HISTORIC DISTRICT REVIEW BOARD MEETING AGENDA

Subject: HDRB #23-008, 754 Elden Street, Herndon Virginia

Subject: Pre-Application HDRB Case, 781-783 Station Street, Herndon Virginia

EXISTING PLAN OF JAMES BUILDING TERRACE
SCALE: 1/8" = 1'-0"

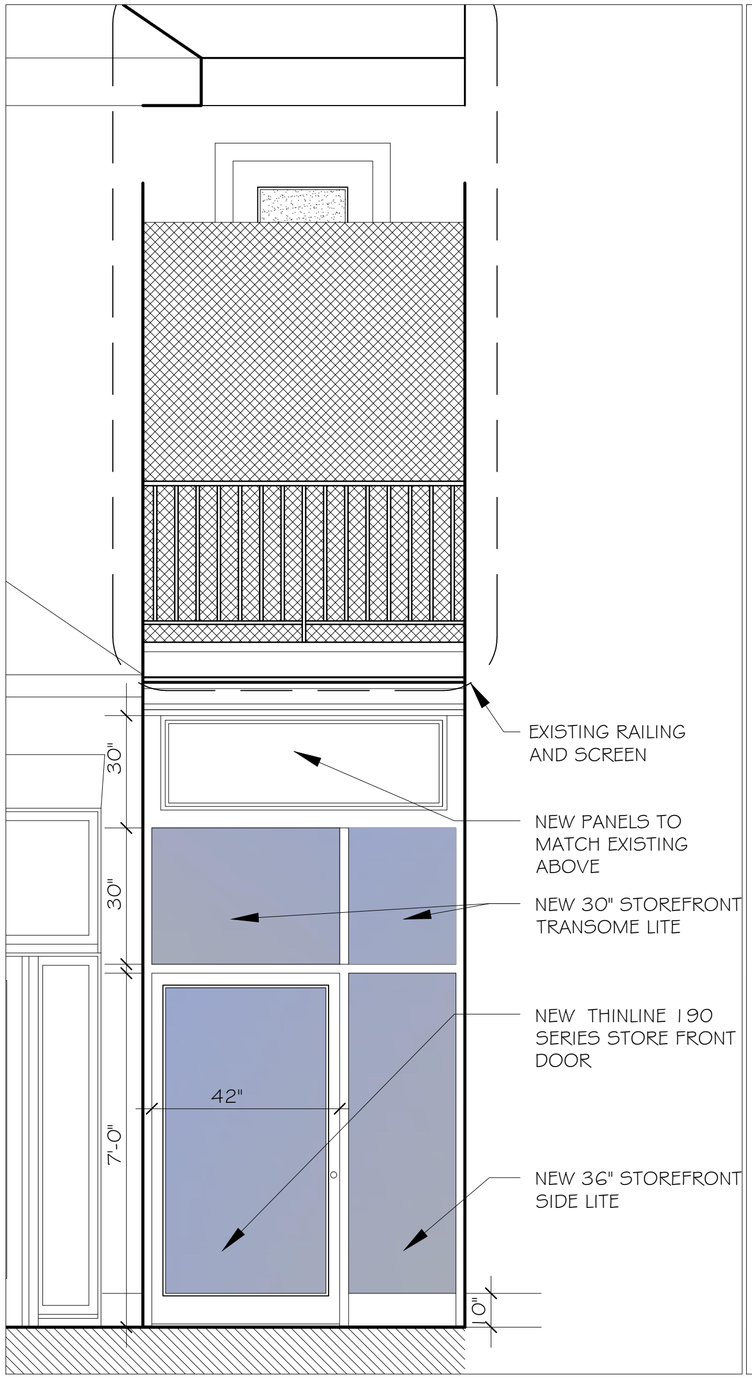
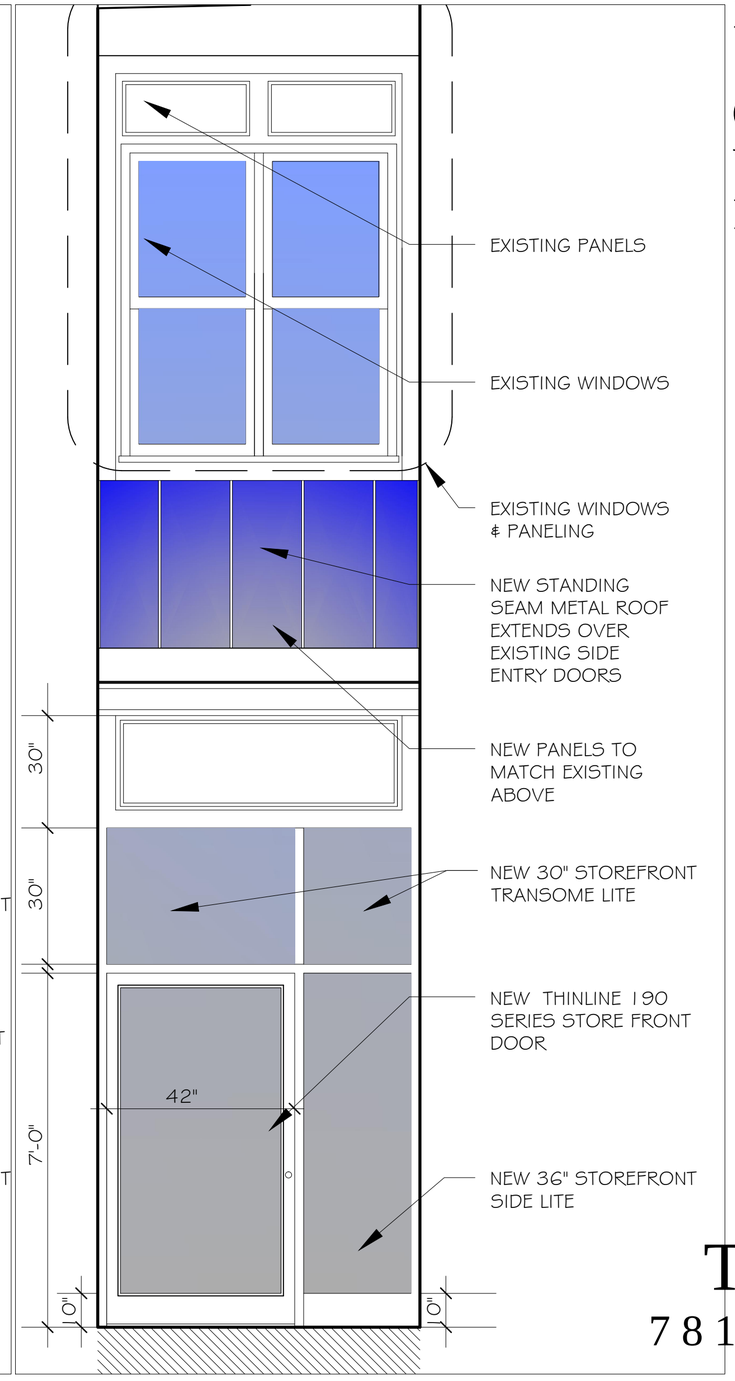
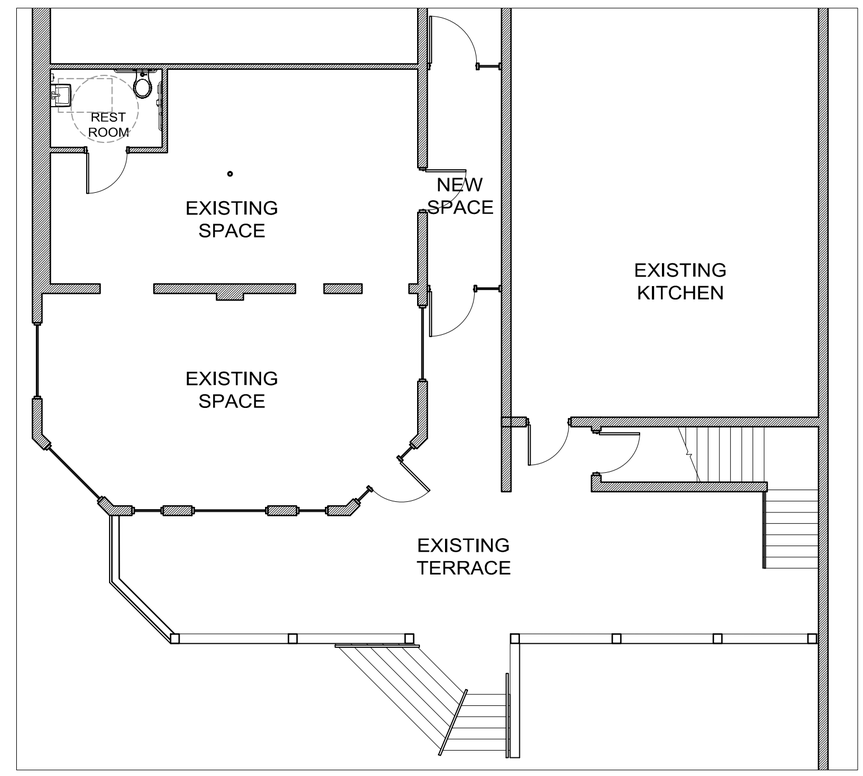
Retaining delineation between buildings. In the staff analysis for HPRB #18-09, the approved application for originally closing off the alleyway which was provided to the Board prior to the July 2018 public hearing, staff emphasized the importance of maintaining delineation between the buildings and retaining an "openness" of the alleyway. The applicant addressed these comments by submitting updated renderings

which included a lower façade primarily featuring fully transparent glazing. It should be noted that this aspect of the design – retaining the appearance of aesthetic of a separation between the buildings with the use of fully transparent glazing was highly emphasized in this case, even when the façade was recessed far back in the alleyway. This project would reduce the area between the buildings and somewhat alter the appearance of the buildings from the right of way. The Board should discuss whether or not the proposed addition which is set back 10 feet from the building facades along Station Street sufficiently retains the separation between the two buildings. Staff believes that the project has potential to still maintain this delineation between the buildings but would seek additional clarifying documents and materials when the application is submitted officially.

Design. The 2018 project approved by the Board in some ways makes this case simpler as the design was previously approved by the Board. A key element from that application was the use of transparent glazing instead of paneling. The Guidelines specifically dictate that there should be a recognizable difference between the new addition and the historic building. As staff understands it, the proposed addition is a modern design that does maintain a differentiation from the historic building.

SITE LOCATION – FAÇADE

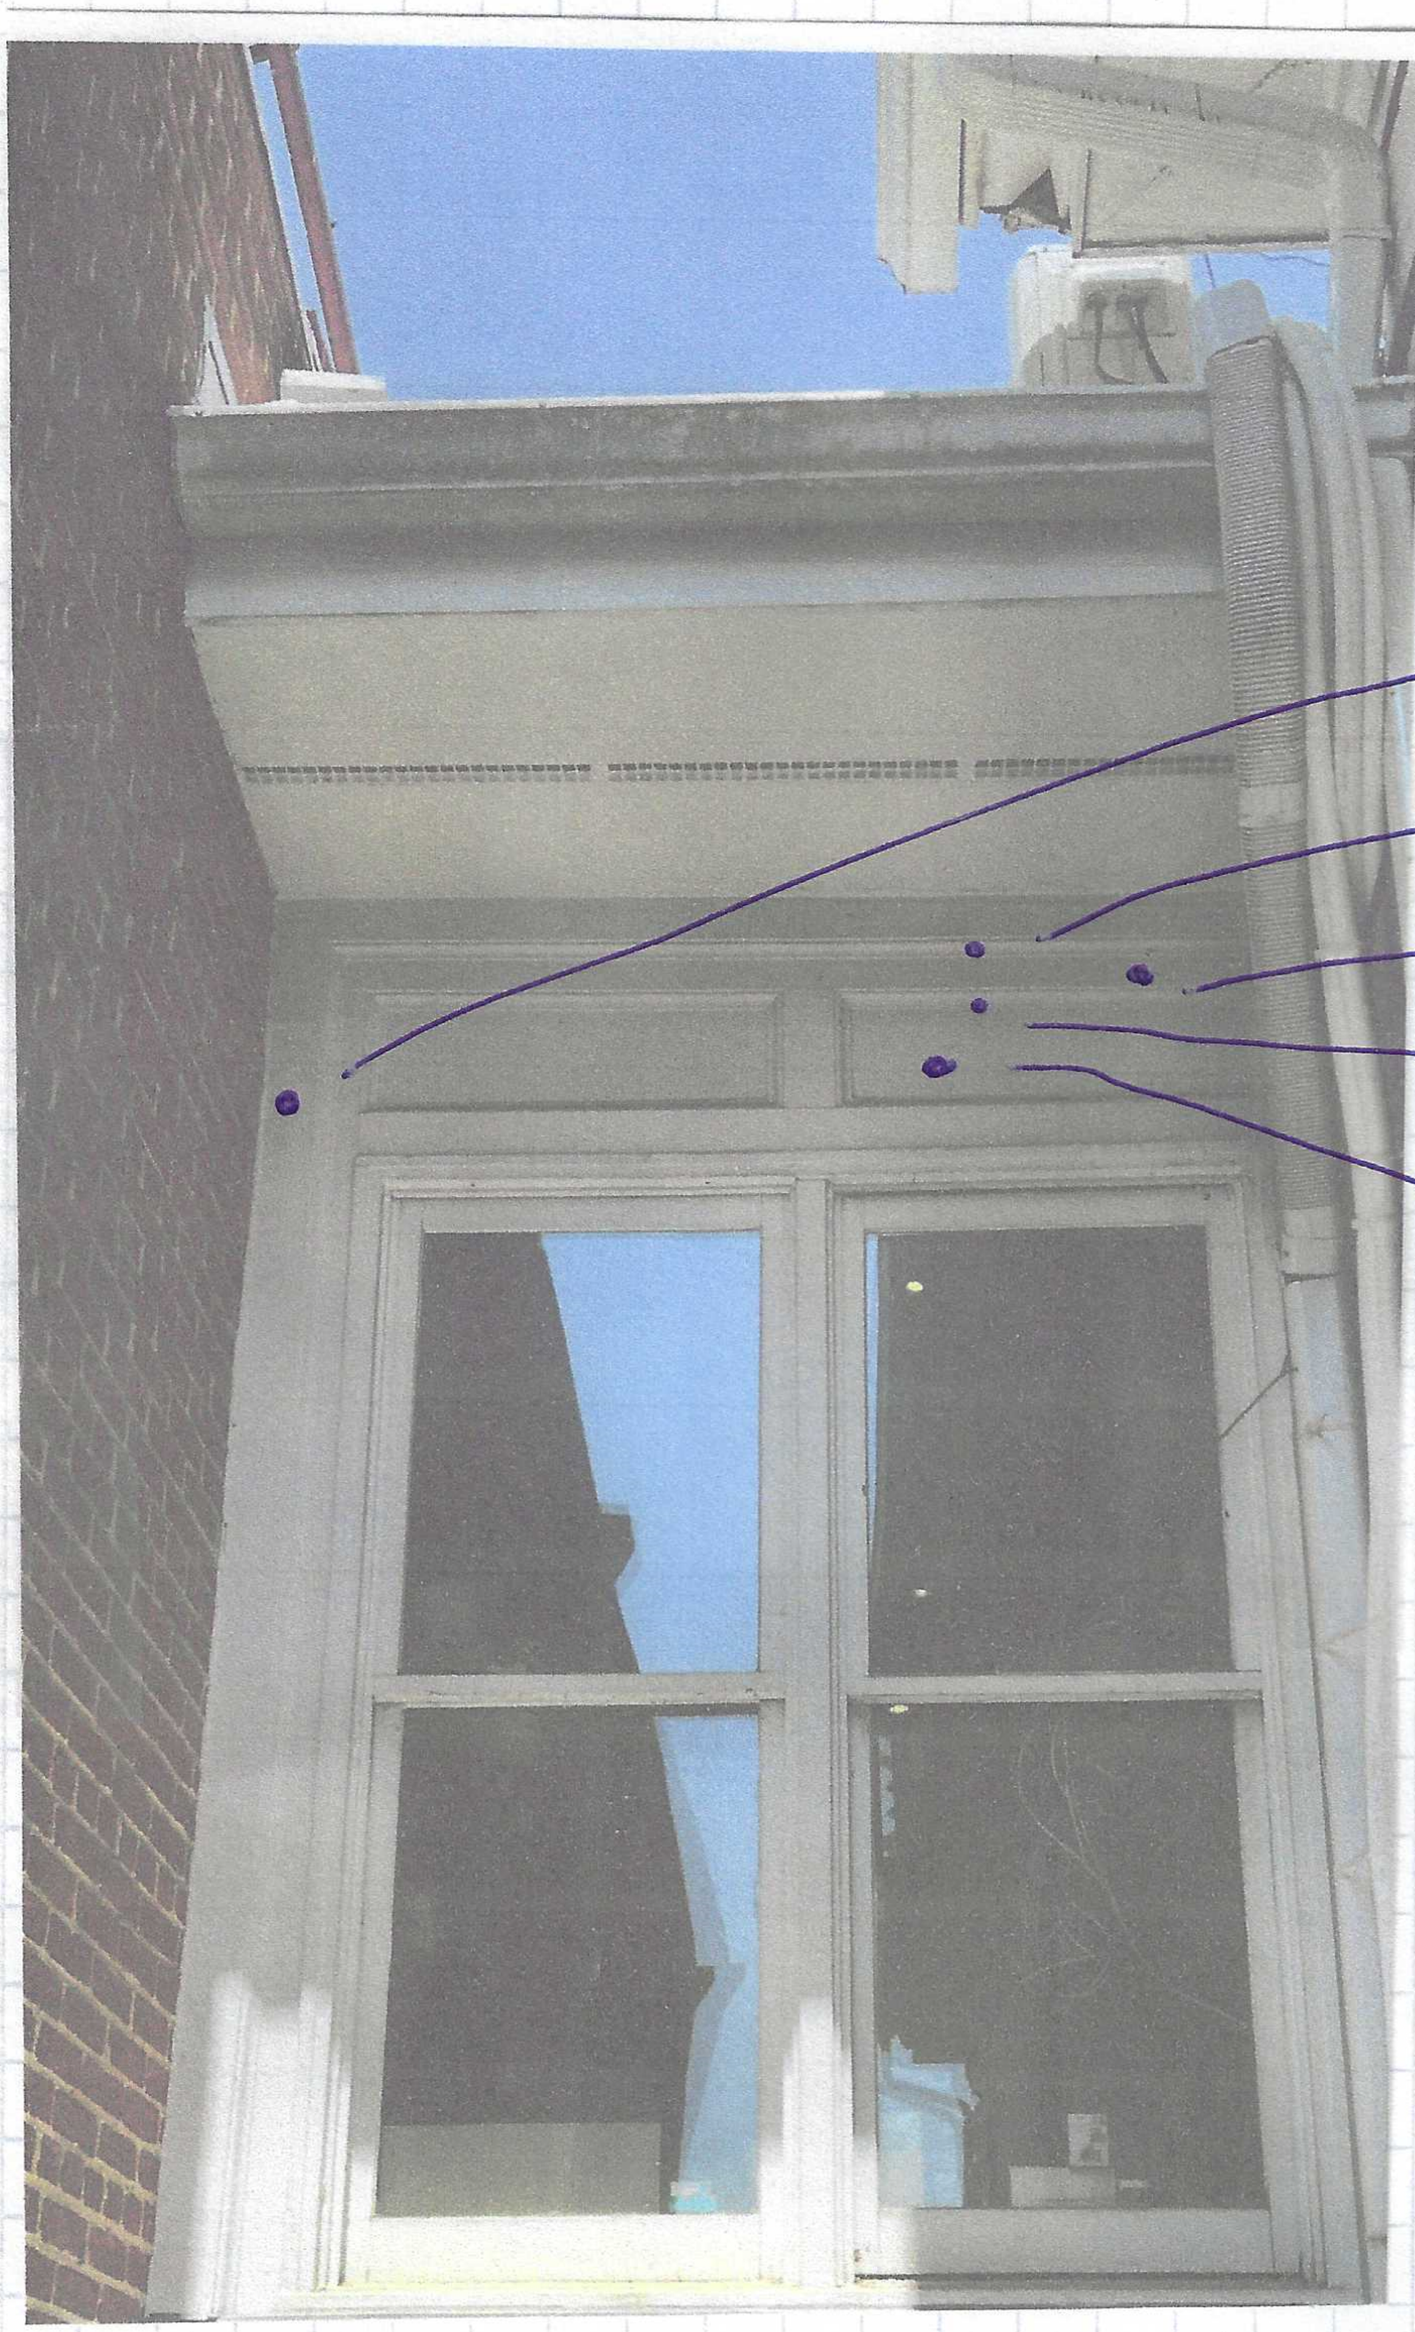
ADDITION CONNECTED @ 2ND FLOOR LEVEL OF 781 STATION ST. ABOVE EXISTING I BEAMS

ADDITION WILL EXTEND TO APPROX 1 TO 2' BELOW PARAPET WALL LINE AND HAVE A FLAT ROOF UNSEEN FROM FRONT ELEVATION

BUILD FRONT & REAR WALLS w/ 2x6 CONSTUCTION EXTEND SOFFIT TO FRONT ELEVATIONS. THIS MAKES FRONT FACADE 10' BACK FROM FRONT ELEVATIONS
